HISTORIC AND DESIGN REVIEW COMMISSION

June 05, 2019

HDRC CASE NO: 2019-289
ADDRESS: 217 PEREIDA ST
LEGAL DESCRIPTION: NCB 949 BLK S PT 3 LOT 17 1/2 & W 20.6 FT OF 13
ZONING: RM-4,HS
CITY COUNCIL DIST.: 1
DISTRICT: King William Historic District
LANDMARK: House
APPLICANT: Gilbert and Leticia Alonzo
OWNER: Gilbert and Leticia Alonzo
TYPE OF WORK: Construction of a 1-story rear addition
APPLICATION RECEIVED: May 20, 2019
60-DAY REVIEW: July 19, 2019
CASE MANAGER: Adam Rajper
REQUEST:

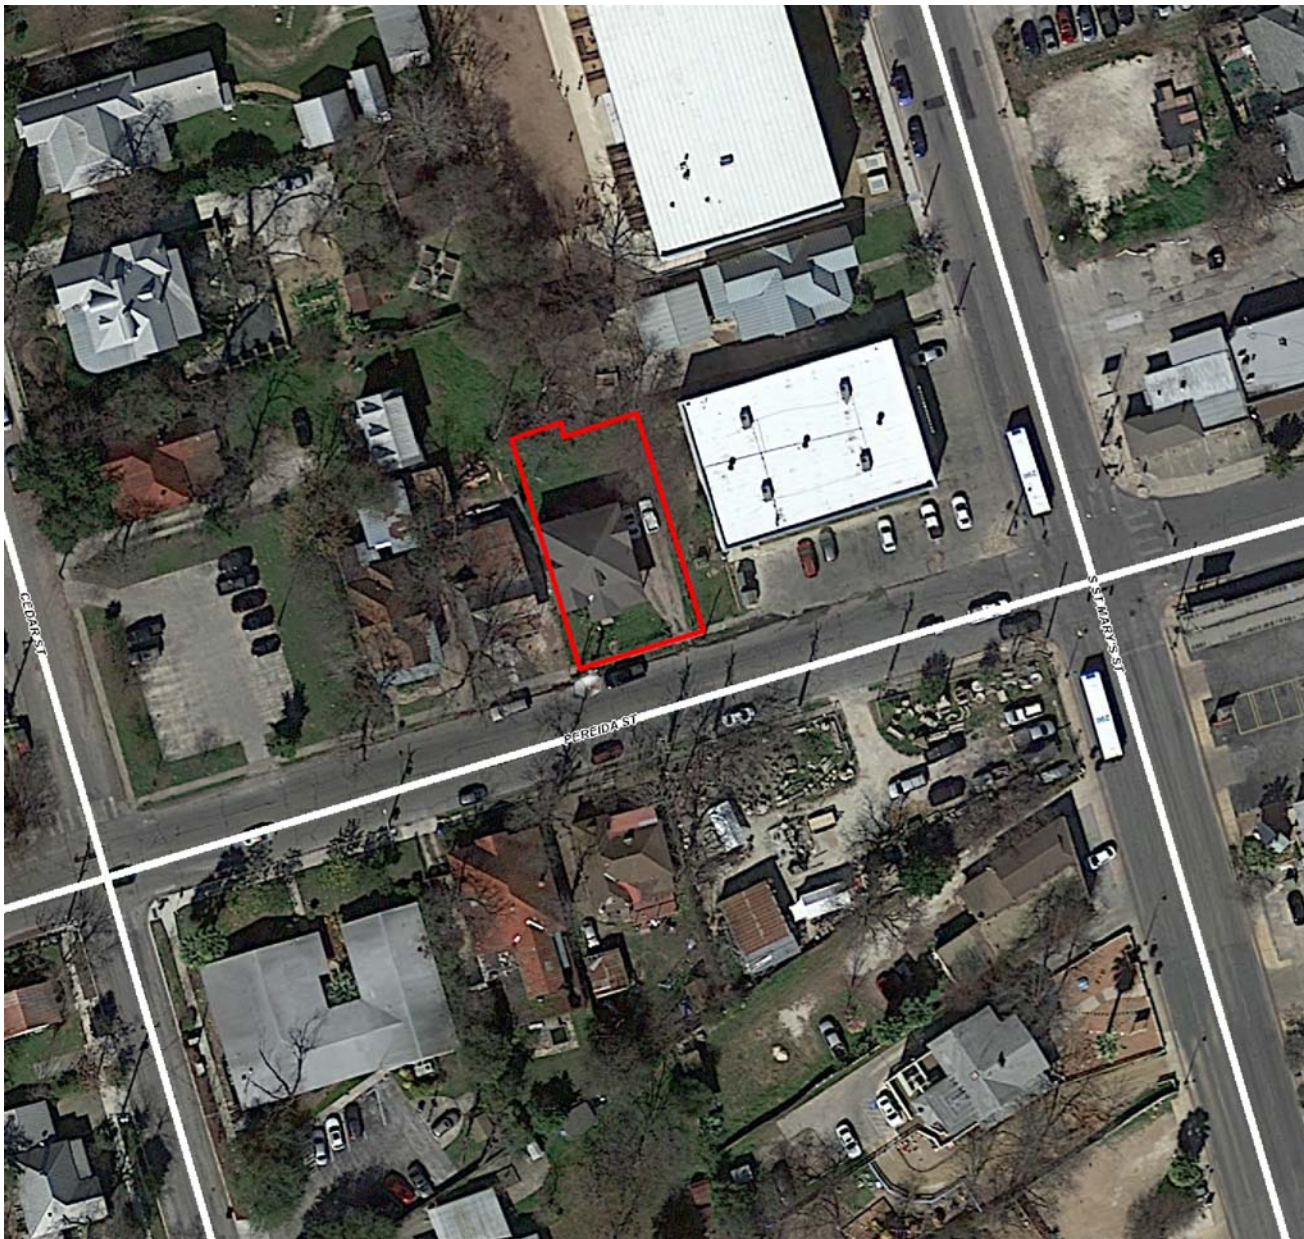
- d. ADDITION: ORIENTATION AND SETBACK – The applicant has proposed to construct a new addition at the rear (north side) of the existing structure. According to Guideline 1.A.iv, a setback or recessed area should be utilized for a

new addition to provide a clear visual distinction between old and new building forms. The addition maintains clear setbacks from the side (east and west) elevations (a setback of approximately 14 feet from the east elevation and a setback of approximately 4 feet from the west elevation). Staff finds the proposal is consistent with the Guidelines.

RIGHT ELEVATION
— SC: 1/4" = 1'-0" —

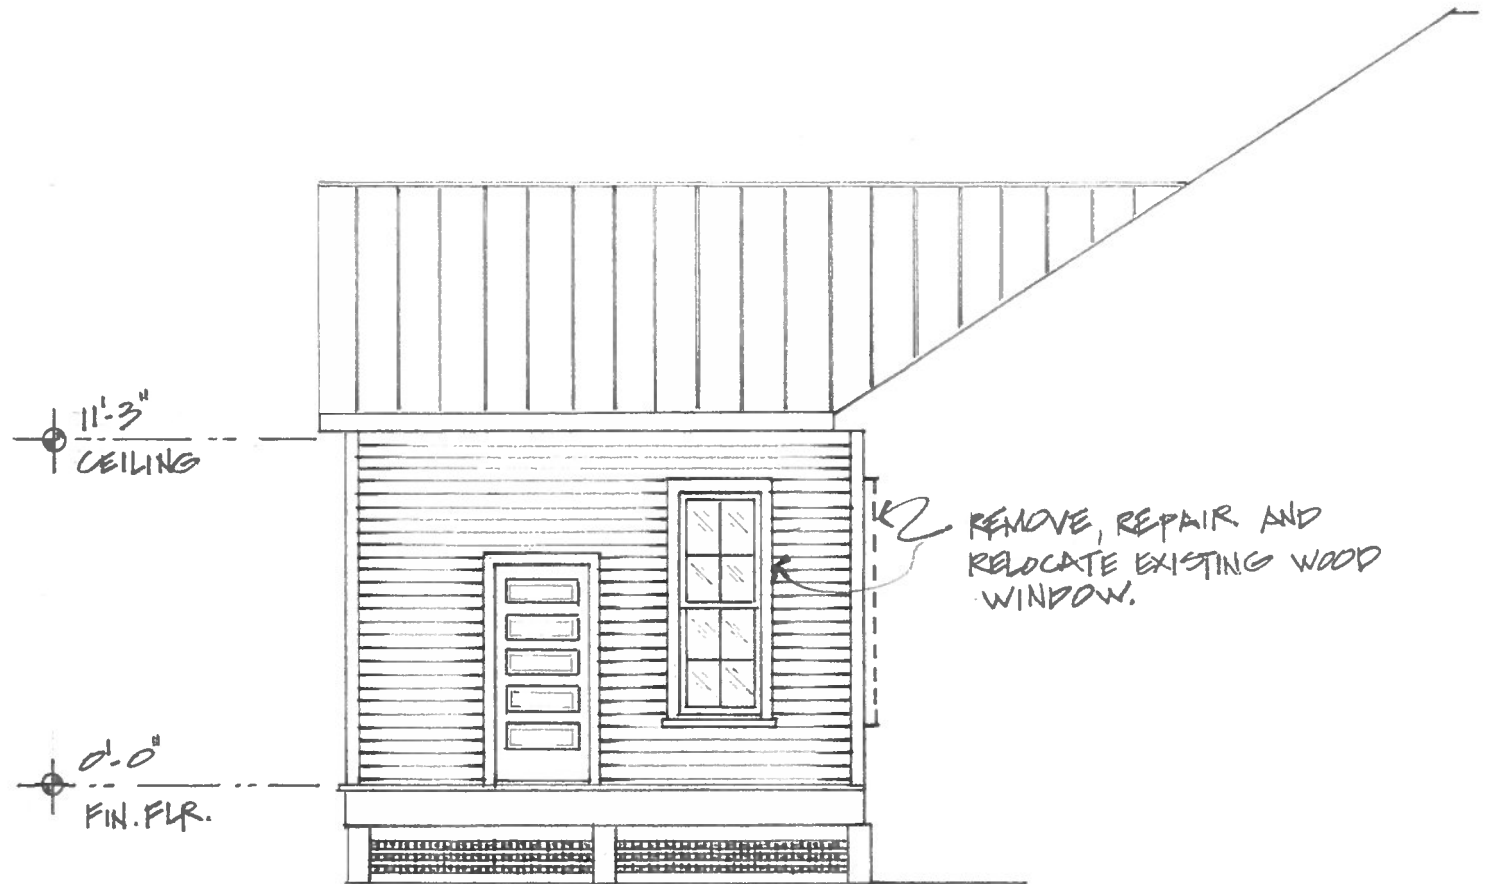
- g. ADDITION: WINDOW AND DOOR MATERIALS – According to the Historic Design Guidelines for Windows, windows used in new construction should feature traditional materials or appearance. The new addition will feature three windows (one on the east elevation, one on the west elevation, and one on the north elevation) and one door on the north elevation. An original wood double hung window will be removed from the existing rear elevation, repaired, and moved to the west elevation of the new addition. For the remaining two windows on the addition, the applicant has specified double hung windows to match the existing on the home. Finally, an original wood door will also be removed from the existing rear elevation, repaired, and moved to the west elevation of the new addition. Staff finds the proposal is consistent with the Guidelines.

- i. That the applicant submits a final window specification for the proposed aluminum-clad wood windows to staff for review and approval. Meeting rails must be no taller than 1.25” and stiles no wider than 2.25”. White manufacturer’s color is not allowed, and color selection must be presented to staff. There should be a minimum of two inches in depth between the front face of the window trim and the front face of the top window sash. This must be accomplished by recessing the window sufficiently within the opening or with the installation of additional window trim to add thickness. Window trim must feature traditional dimensions and architecturally appropriate sill detail. Window track components must be painted to match the window trim or concealed by a wood window screen set within the opening.
